DEPARTMENT OF THE AIR FORCE  
HEADQUARTERS 377TH AIR BASE WING (AFMC)

Please find attached our response to your 22 November 2010 Notice of Disapproval (NOD) 2009 Resource Conservation and Recovery Act Facility Investigation for Solid Waste Management Unit WP-26, Sewage Lagoons and Golf Course Main Pond, September 2009. An extension to 20 June 2011 for submission of our response was approved in your letter dated 7 March 2011.

**Solid Waste Management Unit WP-26, Sewage Lagoons  
Comment Response Matrix**

**Comment Response Matrix**  
**Notice of Disapproval: 2009 Resource Conservation and Recovery Act Facility Investigation Report for**  
**Solid Waste Management Unit WP-026, Sewage Lagoons and Golf Course Main Pond, September 2009**  
**Kirtland Air Force Base, EPA ID# NM9570024423, KAFB-09-011**  
**November 22, 2010**

**Figure 2-22**

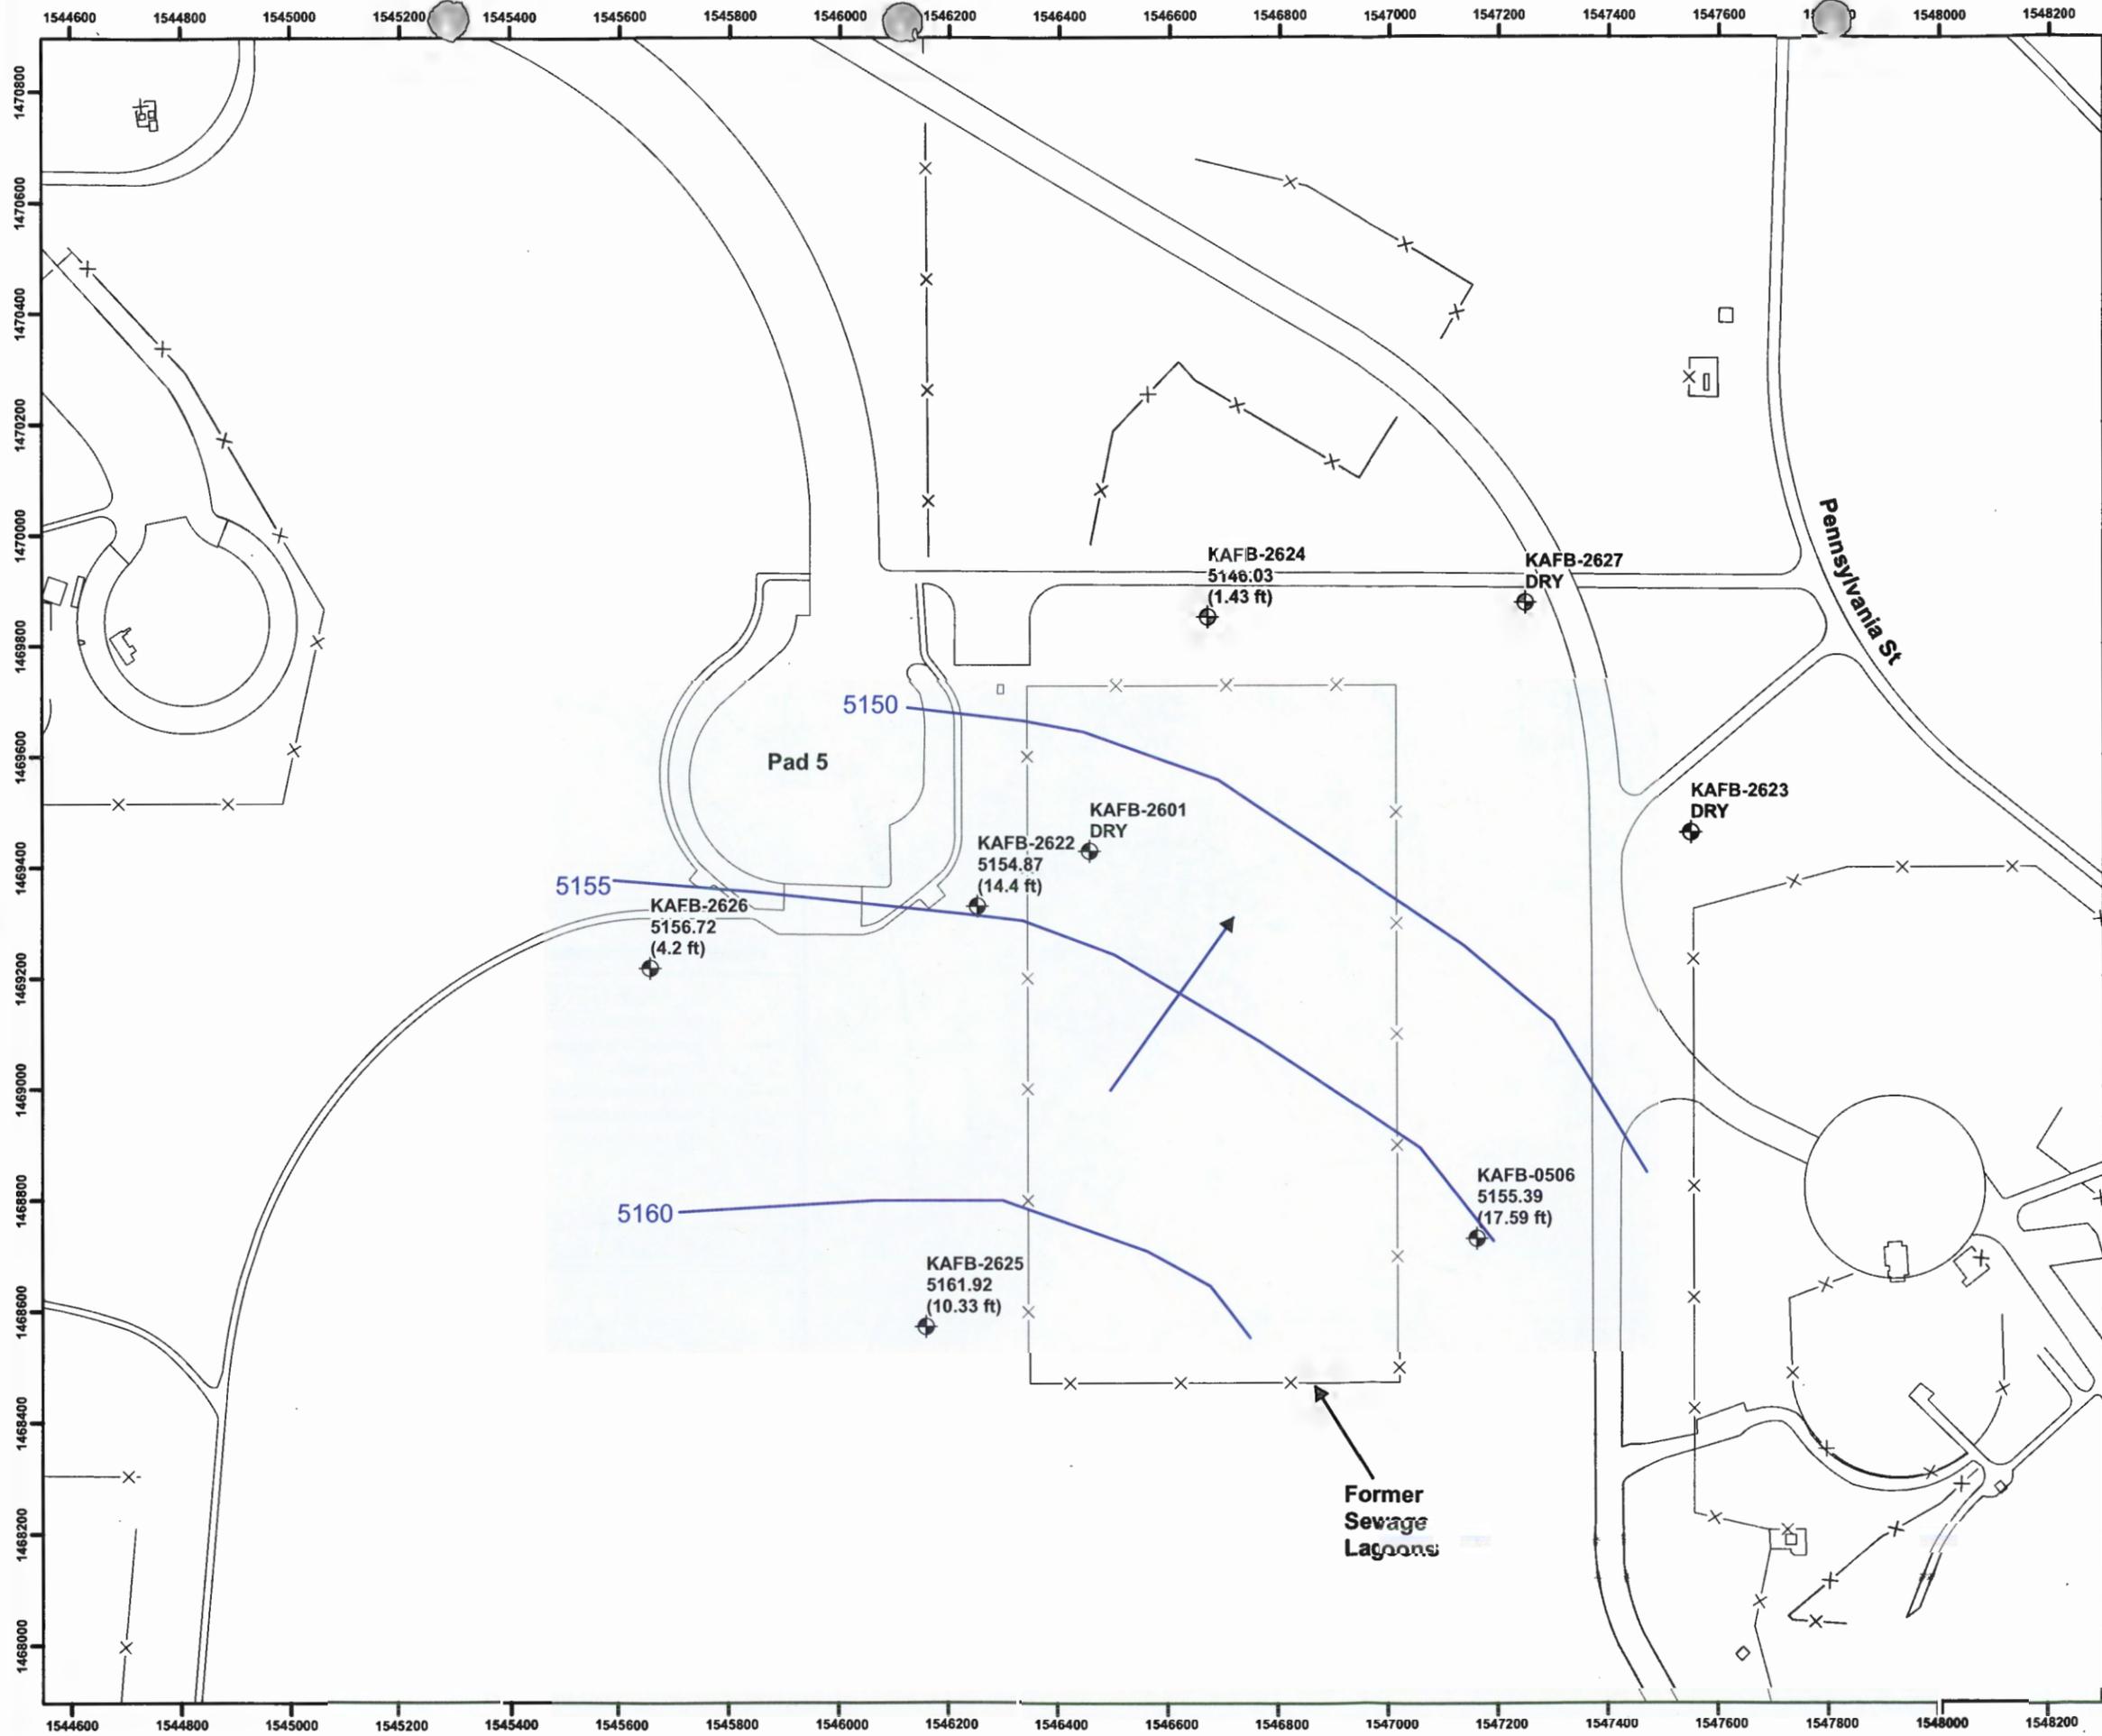
#	Location			Comment	Reviewer	Kirtland Air Force Base's Response
	Page	Line	Section			
1		Figure 2-22		Water-level elevation contours on Figure 2-22 (Groundwater Elevations Perched Zone) do not concur with groundwater elevation data (i.e., the perched aquifer 5,155 ft elevation contour and groundwater elevation data for KAFB-2622 [5154.87 ft]). The Permittee must correct the subject map so that water-table elevation contours are consistent with water-level data.	NMED	The contours were revised and an updated figure is attached.
2		None		Perched water-level elevation contours are not contiguous with other portions of perched systems surrounding WP-026. The Permittee must provide a perched groundwater elevation map that clearly shows the connectivity (or lack thereof) of the perched groundwater at WP-026 with the rest of the perched groundwater around WP-026.	NMED	A review of perched groundwater elevations from the <i>Third Annual Groundwater Monitoring Report for Nitrate-Contaminated Groundwater</i> indicate that perched groundwater contours may be contiguous. The groundwater elevation measured in monitoring well WYO-4 was 5100.82 feet (ft) while the elevation measured in monitoring well KAFB-0506 was 5155.4 ft, both measured in October 2009 (Figure 3-1 from the <i>Third Annual Groundwater Monitoring Report</i> ). These wells are located approximately 3,300 ft apart. Monitoring wells KAFB-2623 and KAFB-2627 are located between monitoring wells KAFB-0506 and WYO-4. Monitoring wells KAFB-2623 and KAFB-2627 are completed within the perched groundwater zone but are both dry indicating that perched groundwater in this area is not continuous between KAFB-0506 and WYO-4. Perched groundwater located beneath the former sewage lagoons and the larger perched groundwater to the east may have been connected in the past but do not appear to be connected at this time based on dry wells located between the two perched water bodies. The perched groundwater beneath the former sewage lagoons appears to be isolated in both saturated thickness and aerial extent.

## WELL COMPLETION DIAGRAM

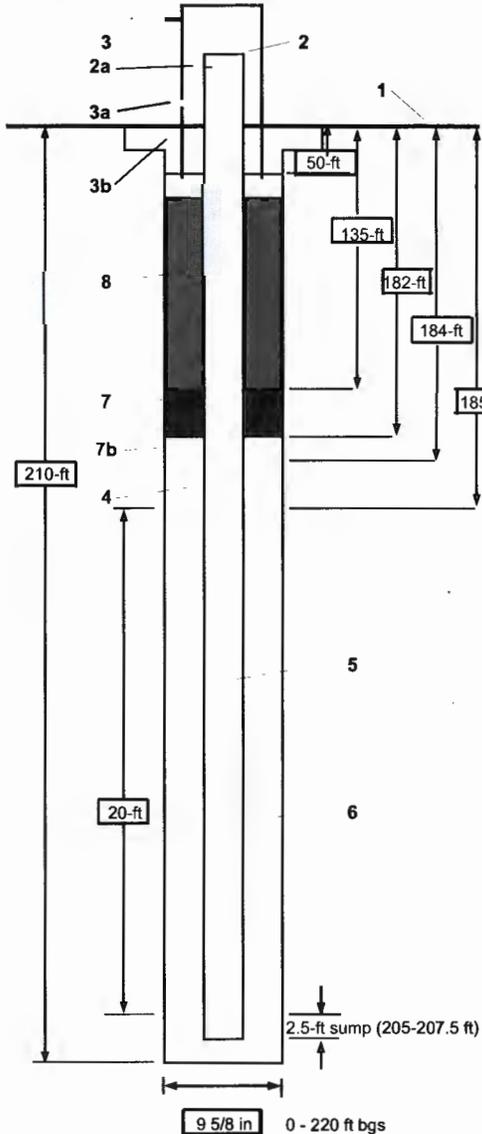
3		None		KAFB-2625: The easting coordinate ("1,1546157.96 ft") reported on the Well Completion Diagram (Appendix D) is erroneous; the correct easting on Figure C-1 is 1,546,157.96 ft.	NMED	The extra 1 from the coordinate was removed from the well completion diagram. The corresponding soil boring log was also corrected.

## WELL COMPLETION DIAGRAM

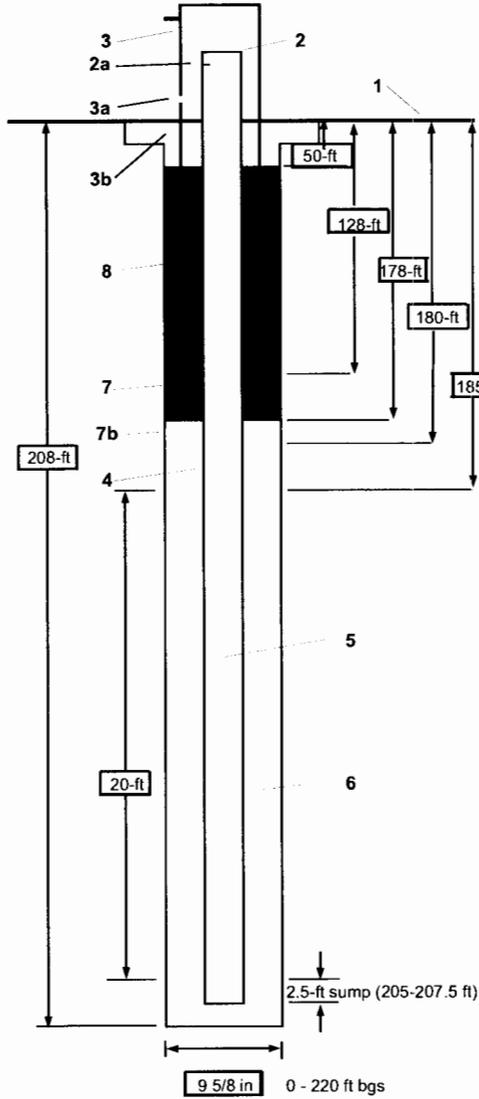
5		None		KAFB-2626: The easting coordinate ("1,1545655.89 ft") as shown on the Well Completion Diagram (Appendix D) is erroneous; the correct easting as shown on Figure C-1 (Appendix C) is 1,545,655.89 ft. The Permittee must correct this error.	NMED	The extra 1 from the coordinate was removed from the well completion diagram. The corresponding soil boring log was also corrected.
6		None		KAFB-2627: The easting coordinate ("1,1547246.35 ft") as shown on the Well Completion Diagram (Appendix D) is erroneous; the correct easting as shown on Figure C-1 (Appendix C) is 1,547,246.35 ft. The Permittee must correct this error.	NMED	The extra 1 from the coordinate was removed from the well completion diagram. The corresponding soil boring log was also corrected.
7		None		The Permittee must provide the Department a copy of the surveyor's plat and survey for each monitoring well and borehole constructed for WP-026, and each monitoring well used for construction related regional and perched groundwater potentiometric surface maps.	NMED	Surveyor's plats were not included within the individual documents that provided the well construction details for the wells installed near the former sewage lagoons. A surveyor's plat can be generated for the site following the installation and surveying of the required groundwater monitoring wells.
